**STAFF REPORT
ITEM NO. A.**

DATE: *December 14, 2015*

ADDRESS: *307 and 315 East Capitol Avenue*

COA REQUEST: *Exterior renovations and signage*

The Paragon Building Existing North Facade 2015

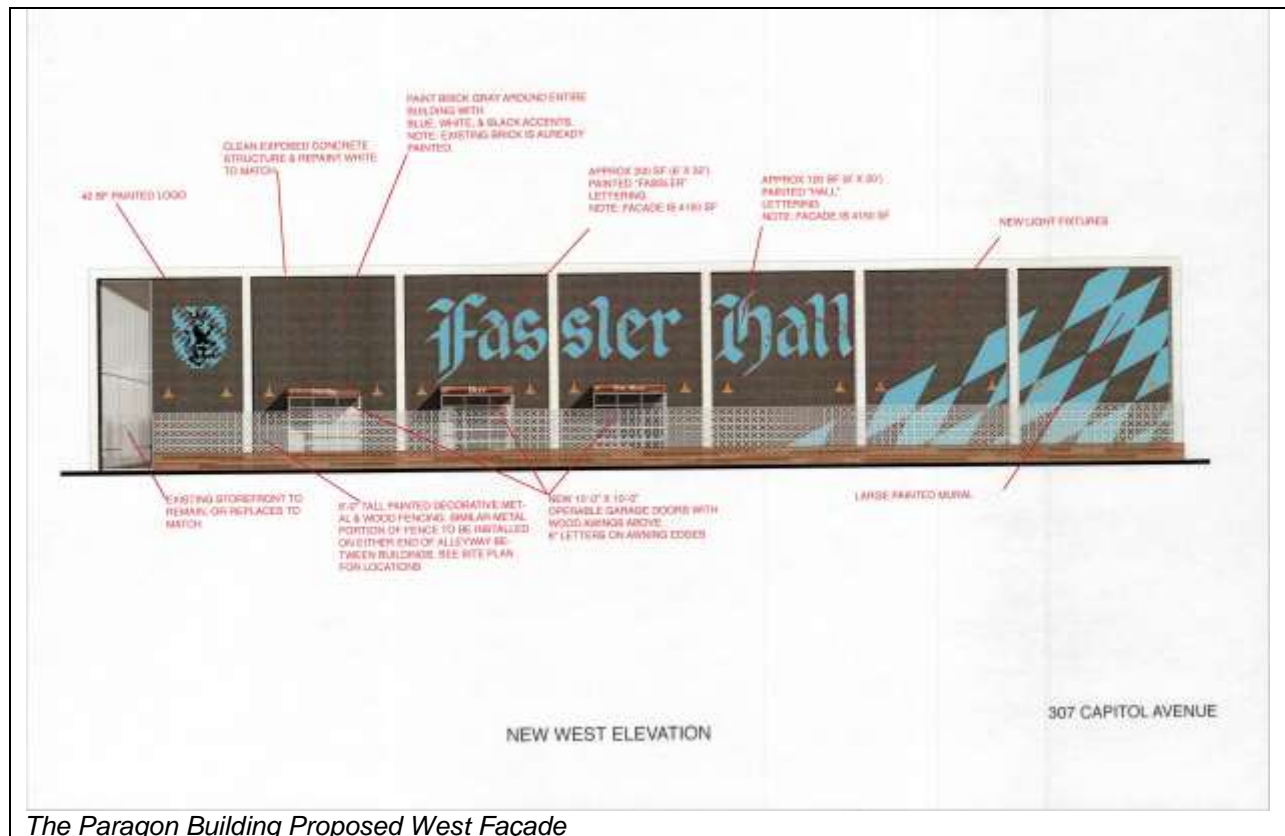
Currently, the building has a single front door in an aluminum storefront system. Changing this to two wooden doors could be reversible in the future. The large panels has four vertical panes of glass now, replacing parts of the two center ones with doors could be appropriate for additional entry and exit from the building. More appropriate doors would be two glass aluminum doors that match the existing door.

In light of the additional information from AHPP, Staff is concerned on the removing or covering of original architectural details. In this Structural Expressionist building, the three elements are the white structural members, the rectangular masses of brick and the two-story glass storefront windows. AHPP believes that the mortar was dyed and matched to the brick and that this front façade brick has never been painted. Evidence of paint on the mortar joints is not there. The guidelines state on page 49 that unpainted masonry should not be painted.

The sign on the front façade of the building could be installed as metal individual cut letters mounted into the brick as the decorative screen is proposed to be. A different color combination could be used if the red/blue was not found suitable. The sign is quite large and measures differently than labeled. The zoning ordinance states that signs must be less than 10% of the façade. This sign appears to be almost at that maximum.

The sign on the front façade of the building measures almost six feet wide by twenty five feet tall. As proposed, the painted sign would be appropriate if the painting of the brick wall behind was appropriate. However, a metal sign with individual cut letters could be appropriate if they were attached into the mortar and stood away from the brick surface. No mention of lighting of the sign was made in the application.

1. Obtaining building permit for each property.
2. Paragon Building:
 - a. Do not paint brick on front (north) façade,
 - b. Sign on front (north) façade to be individual cut metal letters mounted into the mortar joints.
 - c. Reduce size of sign on front (north) façade by 25%.
 - d. Reduce height of fence to 4' including wood slats.
 - e. Sign on West façade to be reviewed by BOA.
3. American Legion Building
 - a. Reduce height of all fences to 4'.
 - b. Reduce number of signs to two. Remove sign on flagpole and smaller wall mounted sign.

The Paragon Building Existing East Façade 2015

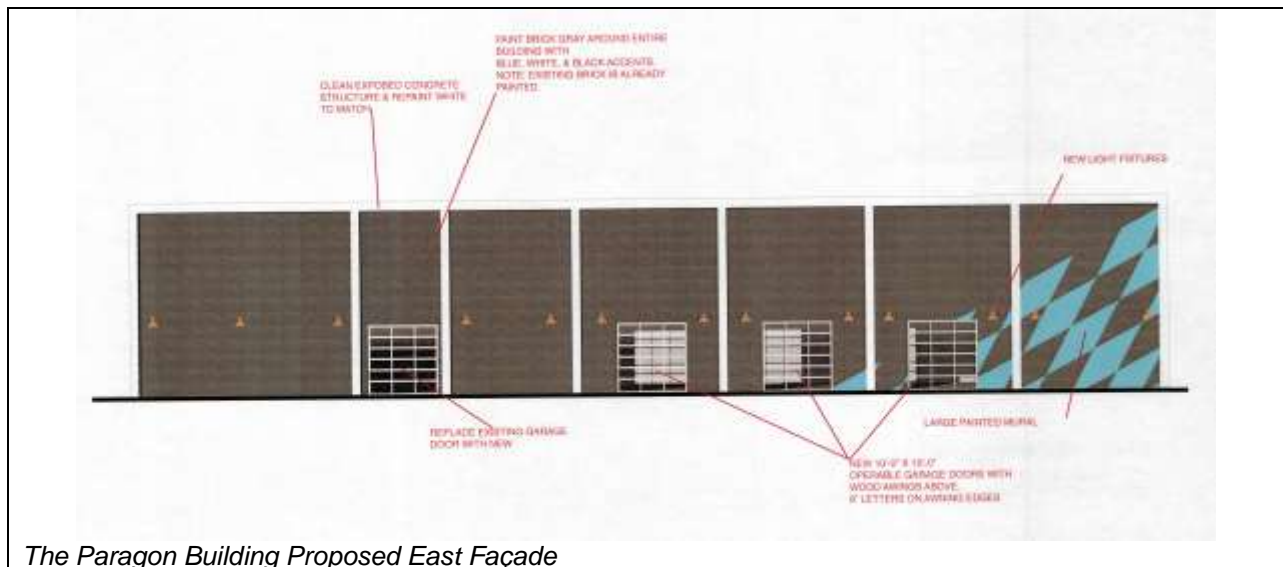
On the east and west façade, it has been painted previously and further painting on these two facades will not diminish the contributing status of the building. Cutting six additional overhead doors into the building may make the building non-contributing in the next survey. Ralph Wilcox, in an email date November 2, 2015, stated "I believe that if the building is renovated and the garage doors are put into the building as proposed, that the project will make the building non-contributing." Mid Century modern buildings are unique to the district.

The sign on the west wall would be appropriate for materials, but may still be oversized at approximately 540 square feet based on the elevation provided. The size noted is incorrect. It will need to be reviewed by the Board of Adjustment since it does not have street frontage. The logo without words on it (diamond shield with griffin) may not be considered a sign. It is 42 square feet. The sign, Fassler Hall, is a sign without street frontage. This sign will require to be reviewed by the Board of Adjustment. Sec. 36-557 (a) All on-premises wall signs must face required street frontage except in complexes where a sign without street frontage would be the only means of identification for a tenant.

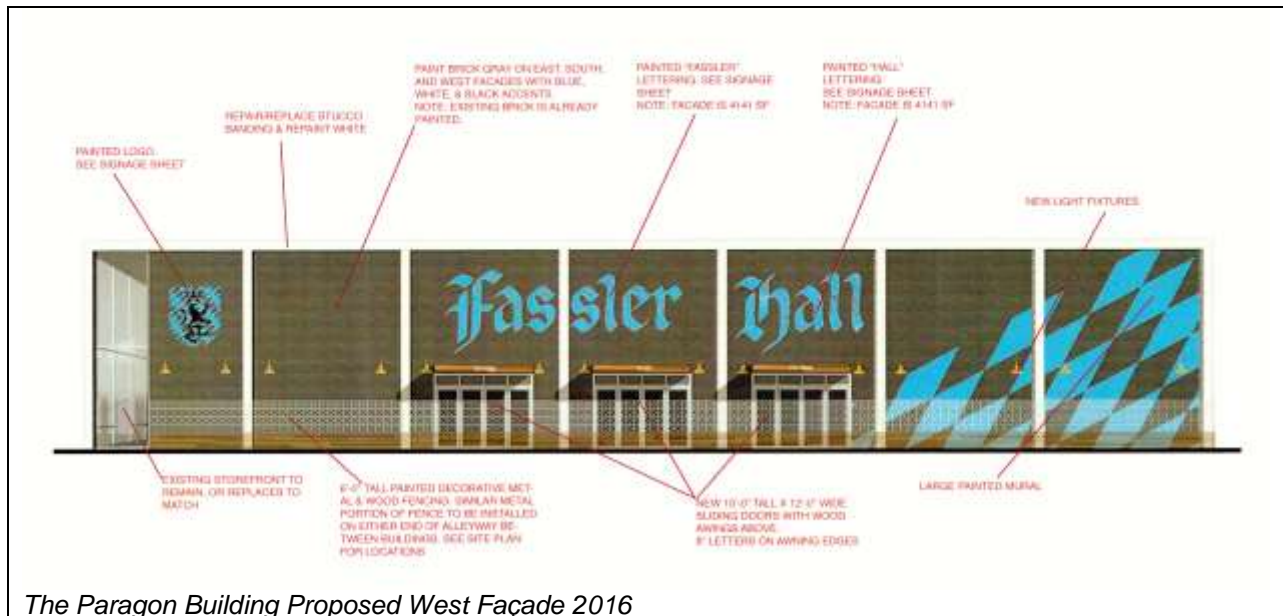
- 30. The single aluminum storefront door would be replaced with two ~~wood doors~~ **two aluminum storefront doors (3'x8')**.
- 31. A 2' x 7' stained and painted carved wood sign would be placed over the new ~~wood doors~~ **aluminum storefront doors**.
- 32. A 12" thick wood awning with recessed lights in the soffit would be added over the front doors at the level of the beam between the first and second floor.
- 33. The red brick panel in the center of the building and the brick to the east of the front door ~~would be painted gray~~ **will not be painted**.
- 34. A perforated metal screen would be added to the building in front of the brick panel. It would be blue in color and have a diamond pattern with cutouts.

35. A sign, varying from 5'-3" to 3'-0" by x 22'8" would be painted on the brick wall mounted metal cut letters painted white, beside of the diamond screen with the words "Fassler Hall". This sign would be painted in white on the grey background.
36. The brickwork on the front of the building will be cleaned and repaired as necessary.
37. There would be a fence added to the west side of the building placed on a wood slat base. The fence and base would be 8'-6'-0" tall. The fence would be a decorative metal fence in a mid-century motif.
38. There would also be a gate installed in the alley on the east side of the building in the decorative mid-century motif. It would not have a wood slat base. It will be 6'-0" tall.

The applicants have met most of the recommendations and suggestions in the previous Staff report including the changes to the front doors, not painting the front façade, and changing the signage and screen on the front so that the original masonry is preserved. The fence height has been amended from 8' to 6' in the December hearing.

1. Obtaining building permit for each property.
2. Paragon Building:
 - a. Sign on West façade to be reviewed by BOA.
